Roseville College SWELL Building

Access Review - DA

22 October 2019

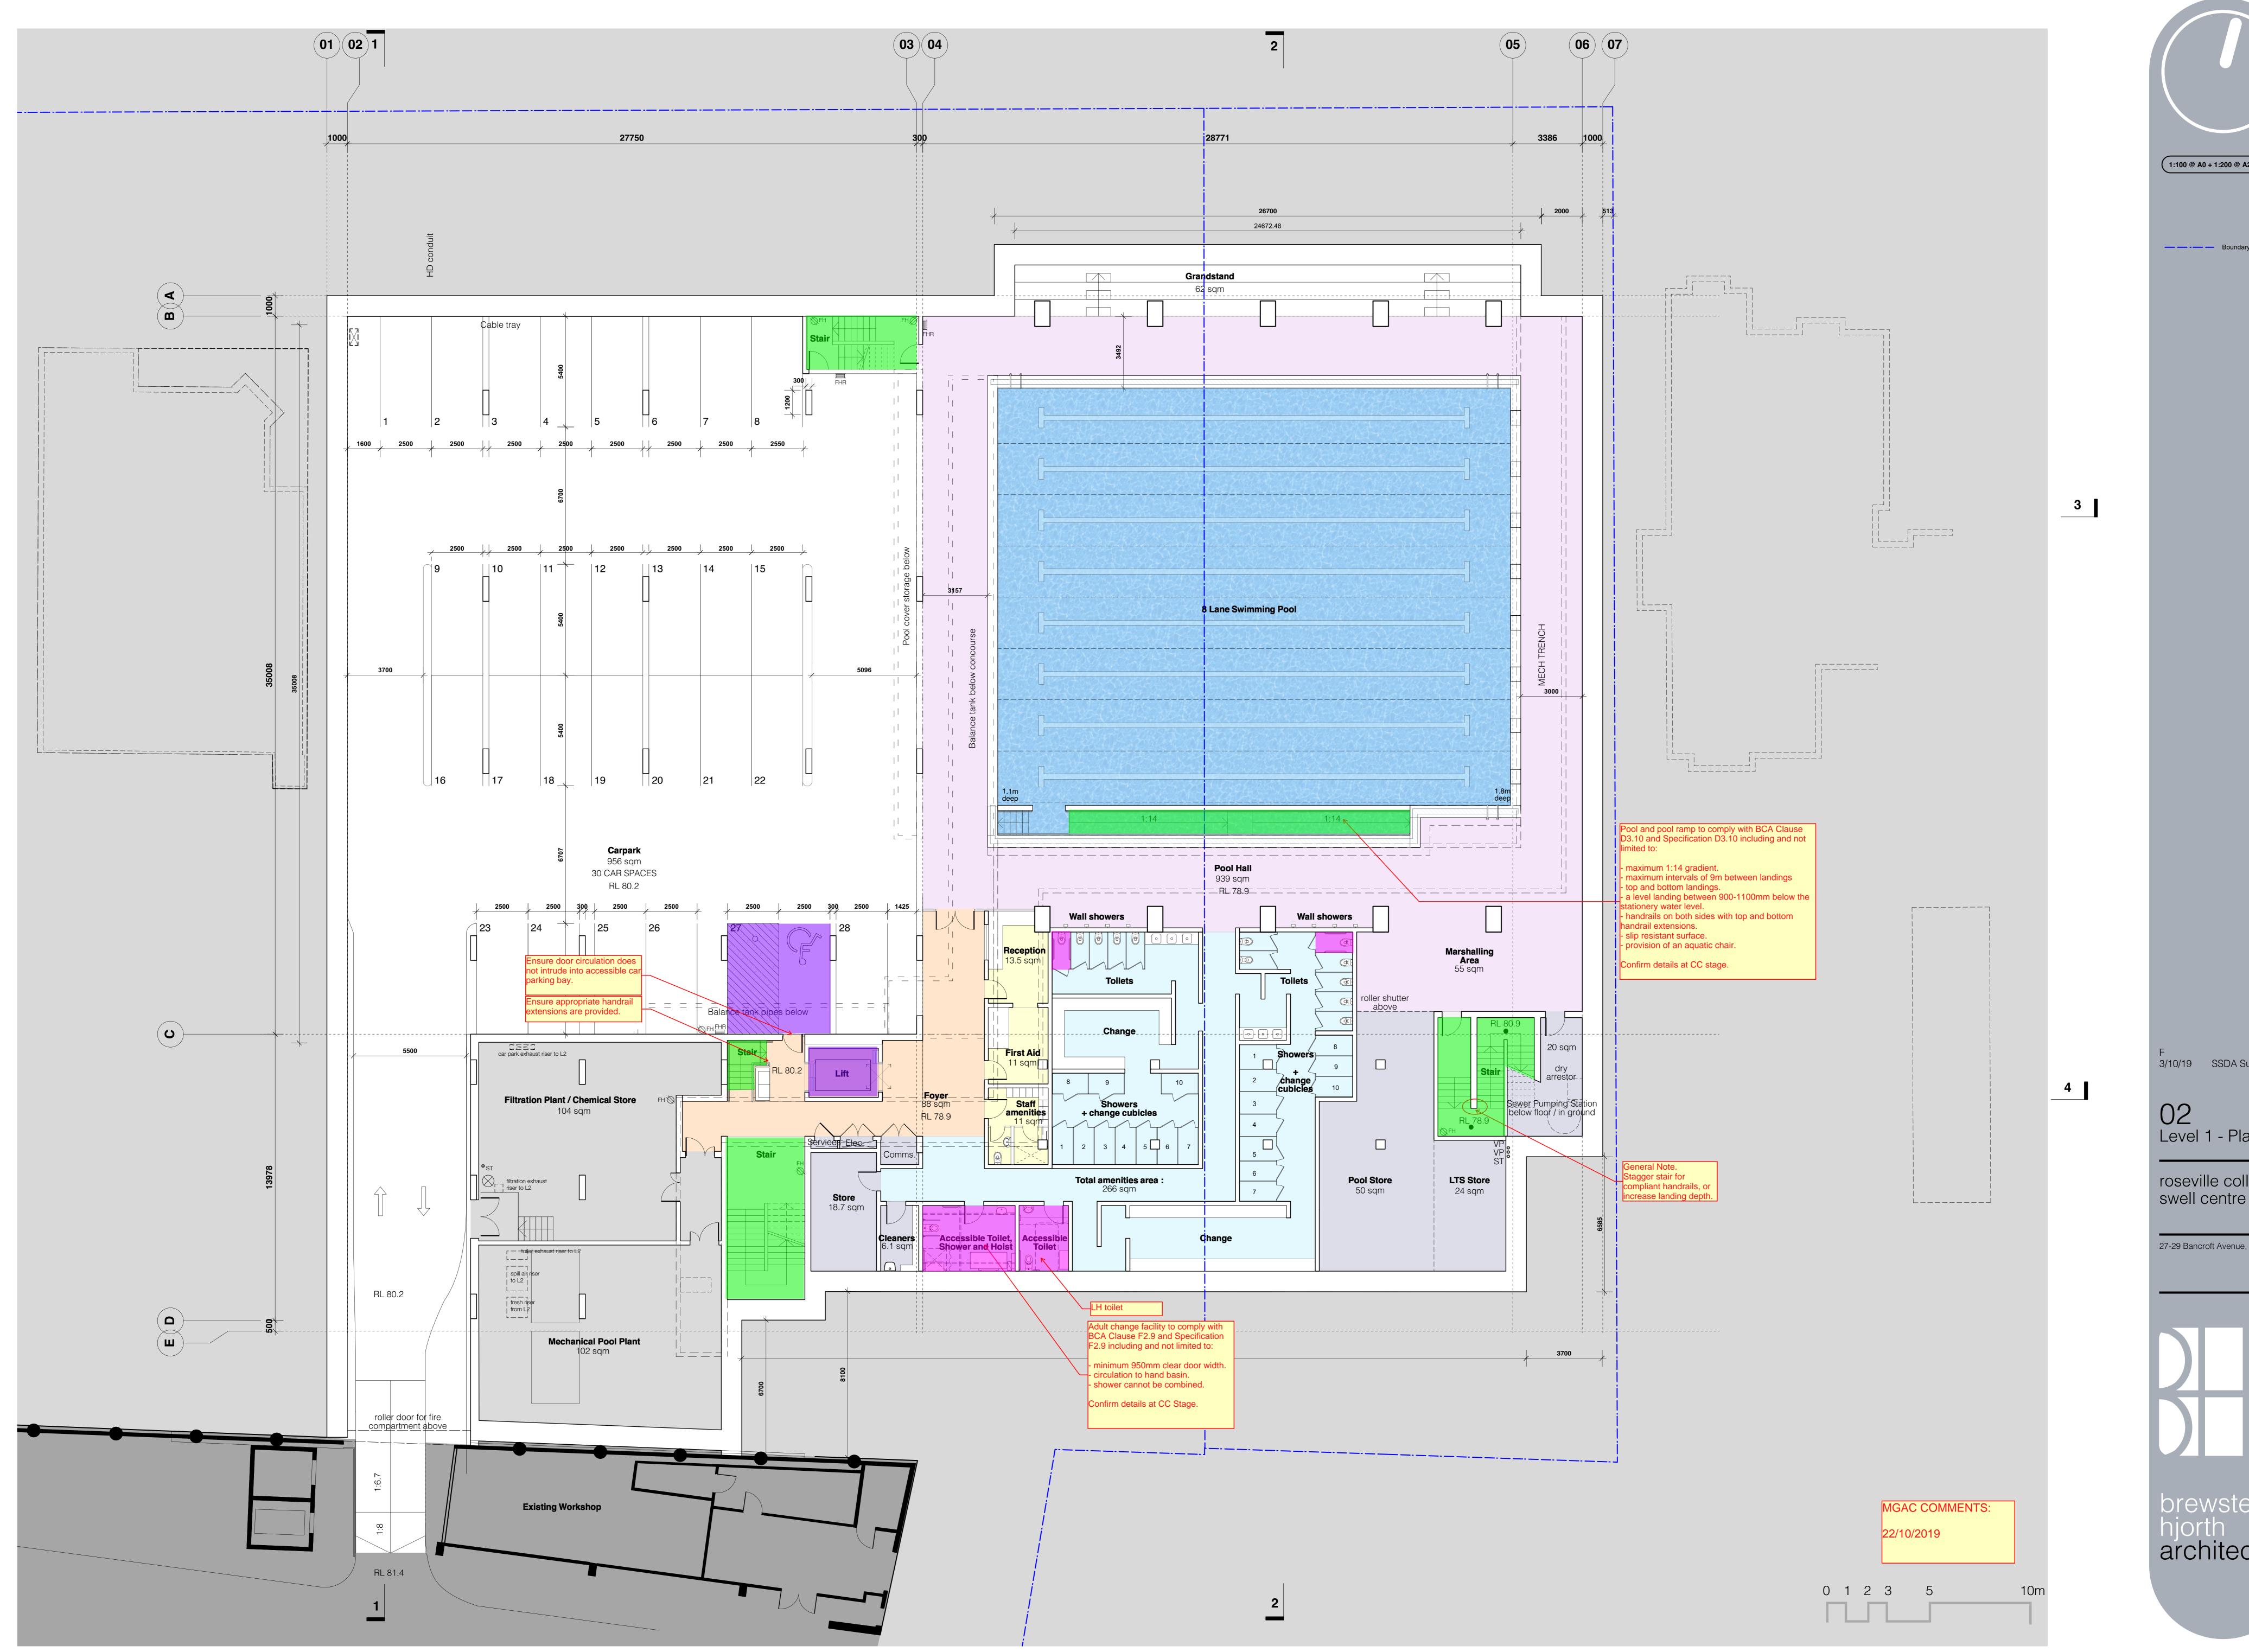
- Any inaccessible entrances that are more than 50m from an accessible entry will require the provision of access.
- Confirm entry from Bancroft Ave is an entry or for fire egress purposes only. Consideration of access may be required if this is an entrance and is more than 50m from an accessible entry.
- Ensure door circulation does not intrude into the accessible car parking bay on level 1.

All fire isolated stairways appear capable appropriate with the exception of the stairs south of the marshalling are requiring the stair to be staggered or landing depths increased for compliant handrails at detail design stage. Ensure details to BCA and AS 1428.1 requirements.

The general layout of the open stairs appear appropriate with the exception of the stair adjacent to the lift on level 1 requiring appropriate handrail extension before turning – to be considered at design development stage. Ensure details to BCA and AS 1428.1 requirements.

The layout of the accessible toilets provided appear appropriate with the exception of the provision of equal LH and RH pan requirement. Ensure this is addressed in further design stages.

Ensure details to BCA F2.9 and Specification F2.9 requirements and refer mark up for comments.

The size and layout of the accessible carparking spaces provided appear appropriate with the exception of the door circulation space to the entrance door required to be outside of the accessible car bay. Ensure details to BCA and AS 2890.6(2009) requirements.
